## Product Change Notice (PCN)

**PCN Number:** PCN-0451317R-01

**Product(s) Affected:** PD-30S and PD-40S

**Description of Change:** Housing, materials, and PCB layout changes as shown below.

### Old Design PD-30S

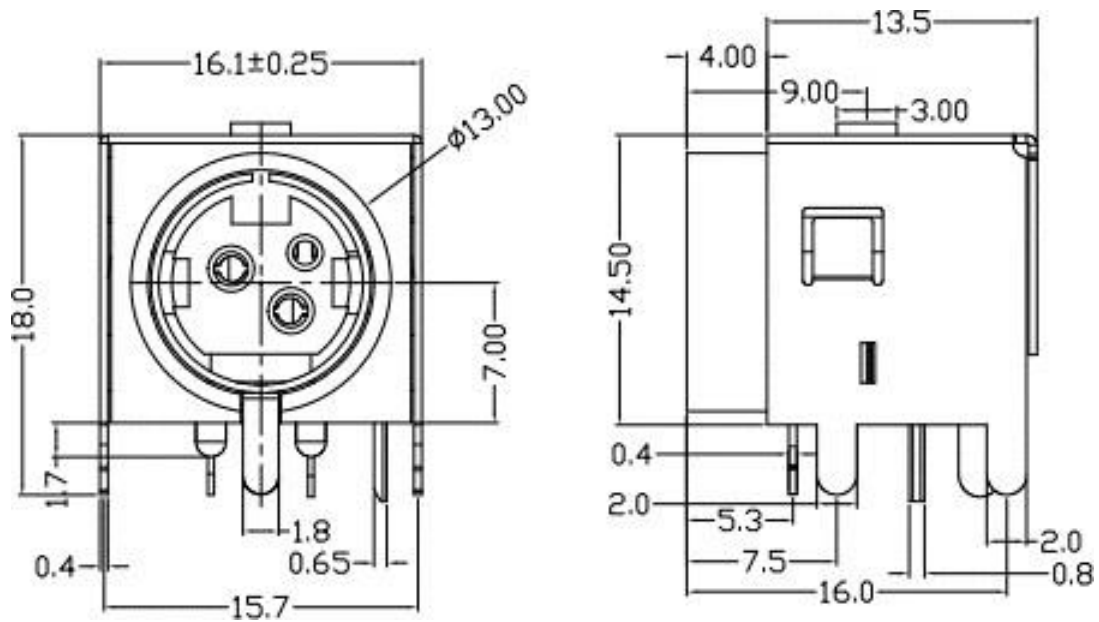
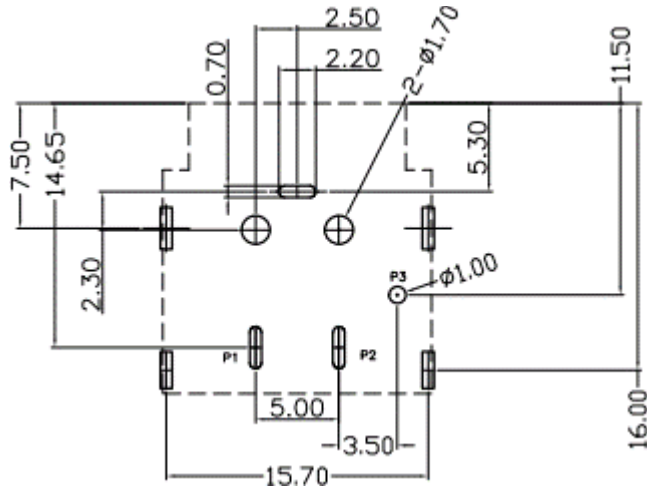
MATERIAL	PLATING
TERMINAL 1	Phosphor Bronze	Tin
TERMINALS 2-3	Brass	Tin
EARTH TERMINAL	Brass	Tin
SHIELD	Steel	Tin
HOUSING	PBT

MATERIAL	PLATING
housing	PBT (UL94V-0)	
contact	phoshor bronze	silver
ground	brass	nickel
shell	SPCC	tin

**Old Design PD-40S**

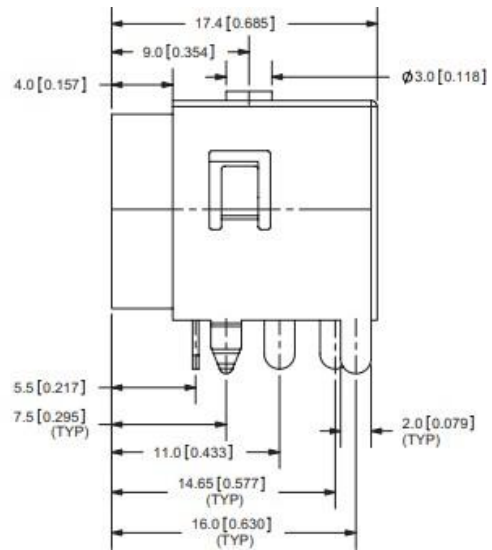
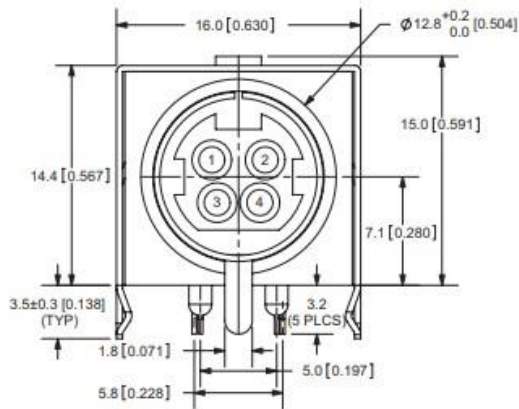
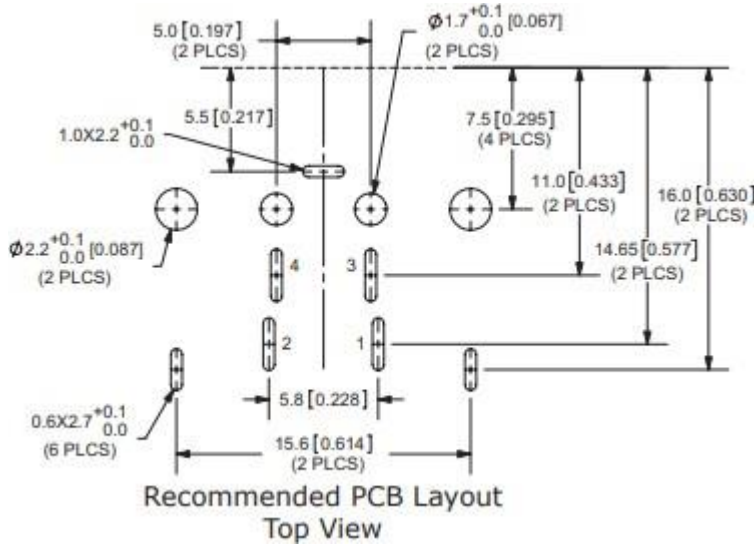
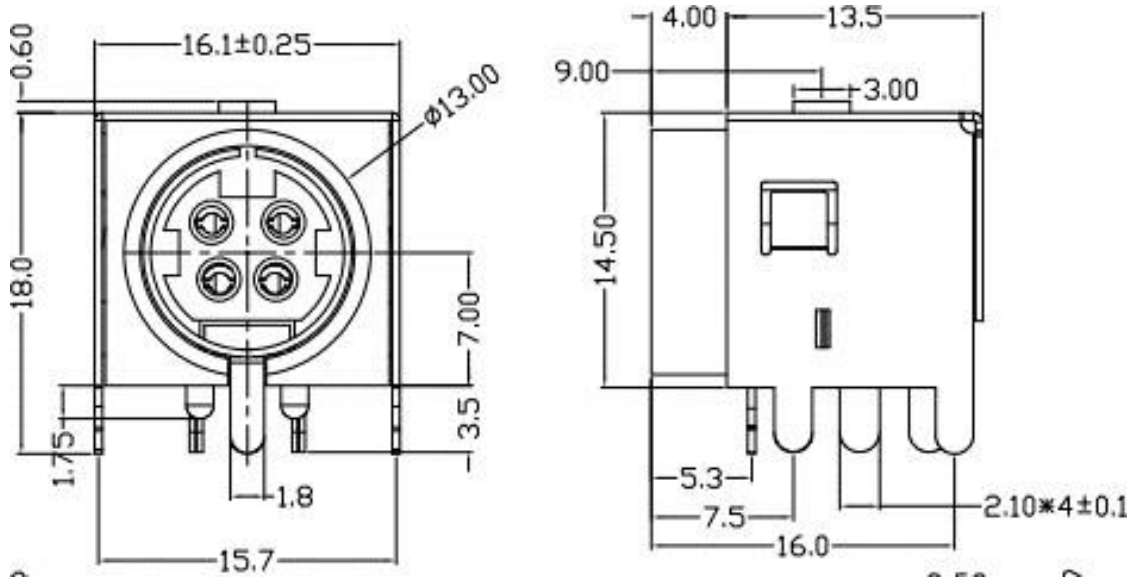
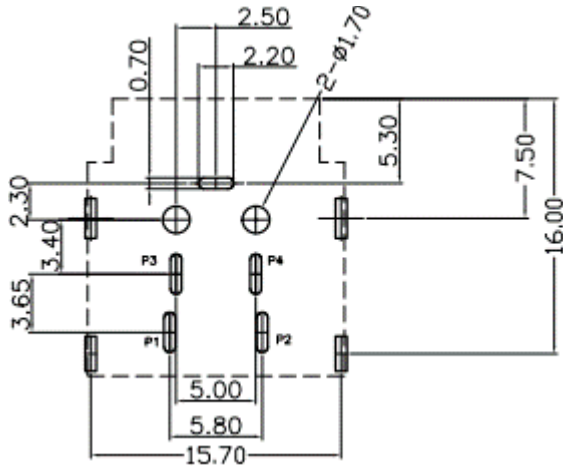
MATERIAL	PLATING
terminal 1	brass	tin
terminal 2	brass	tin
terminal 3	brass	tin
terminal 4	brass	tin
earth terminal	brass	tin
shield	steel	tin
plastic	PBT

MATERIAL	PLATING
housing	PBT (UL94V-0)	
contact	phosphor bronze	silver
ground	brass	nickel
shell	SPCC	tin
